SAFETY RECALL NOTICE

Re: Brake Fluid Reservoir Caps Replacement

Campaign no.: 2008-0002

Date: **January 11, 2008**Subject: **Brake Fluid Reservoir Caps Replacement**No. **2008-2**

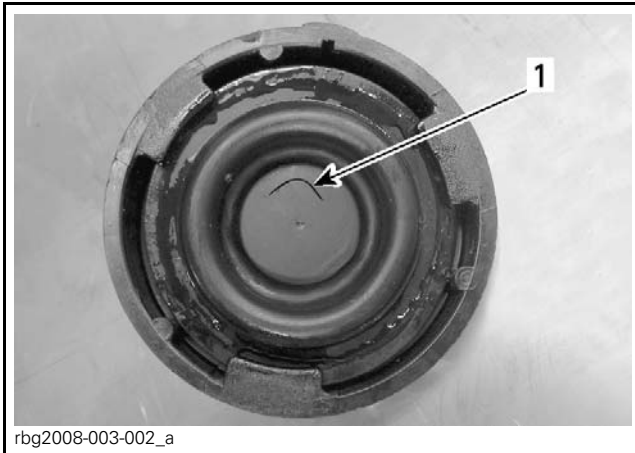
Clean brake fluid reservoir caps [1] and surrounding area.

The above illustration shows an improved brake fluid reservoir cap with the new V slit [1] in the diaphragm.

Install both improved brake fluid reservoir caps (P/N 219 800 058) onto vehicle.

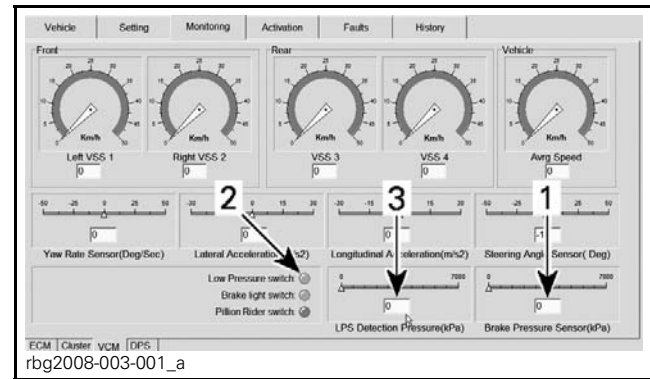
As per the above picture :

- [1] : Brake Pressure Sensor value
- [2] : Low Pressure Switch button
- [3] : LPS Detection Pressure value

If low pressure switch button is still off when you reach the required pressure the validation is successful.

If low pressure switch button turns on before reaching **3500 kPa (508 PSI)** perform the following additional steps :
